# SYDNEY CENTRAL CITY PLANNING PANEL

# **COUNCIL ASSESSMENT REPORT**

Panel Reference	2019CCI015		
DA Number	DA/961/2015/D		
LGA	City of Parramatta Council		
Proposed Development	Section 4.55(2) Modification to DA/961/2015 for the approval for a mixed-use development comprising 607 residential apartments and 24 commercial tenancies within a building with a 4 storey podium and 3 tower forms, two level basement with capacity for 688 car parking spaces. The proposed modifications include an additional ten (10) residential apartments on levels 11-20 to the western building (Tower C) resulting in a total of 617 residential units, amendments to the apartment layouts on levels 2-20 to to the western building (Tower C) resulting in an overall increase of gross floor area of 742.3m², from 57,140.7m² to 57,883m² and changes to the structural columns to the western building (Tower C). The application is to be determined by the Sydney Central City Planning Panel.		
Street Address	Lot 50 in DP 1238546, 38 Cowper Street, GRANVILLE NSW 2142 (formerly known as 14-38 Cowper Street, 21-41 East Street and 5-5A Rowell Street) GRANVILLE NSW 2142

# ASSESSMENT REPORT – MODIFICATION OF CONSENTS Environm

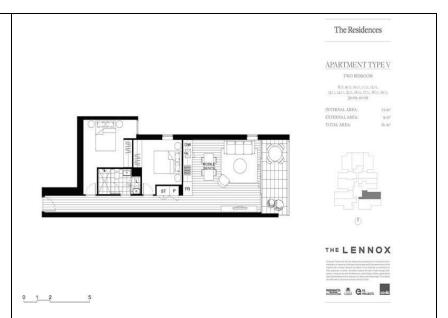
The new Tower C layouts have resulted in the narrowing of the snorkel slots to bedrooms in units C.L 01, 06, 07 and 13. While snorkelled bedrooms are already considered undesirable due to the restrictions in natural light and ventilation, further narrowing them reduces their amenity. The Panel recommends widening the snorkels to a minimum width of 3.6 metres matching what was previously approved in DA/961/2015/A.

It was mentioned during the DEAP meeting that Council would consider the introduction of a blade wall and slab extensions to improve the privacy between adjacent windows within the 'snorkel'. Additional privacy screening is provided in the form of a blade louvre as shown on the floorplans drawings DA1.10, DA1.11, DA1.12 and west elevation DA2.04.

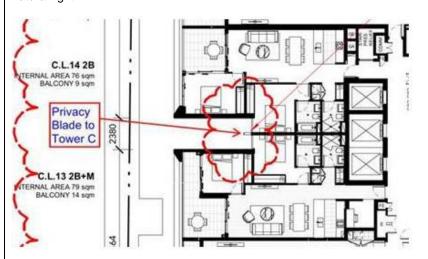
There is precedent within Parramatta LGA at 'The Lennox' 333 Church St where 2 bedroom units have snorkel windows at the end of an approximately 8m deep x 2m wide slot, and a second bedroom also opening to the slot. See images below and indicative floorplan.

These slots form a distinct architectural feature that enhances the slenderness of the three tower elements. A similar approach was successfully applied to the Lumiere Suites in the Sydney CBD and Central Park Sydney.

The application has been revised with the introduction of façade in blade element in the snorkel between the windows and extend the floor slab to match to enhance the privacy between adjacent windows – see extract below. The surfaces within the slot will be a white colour that will reflect natural light.
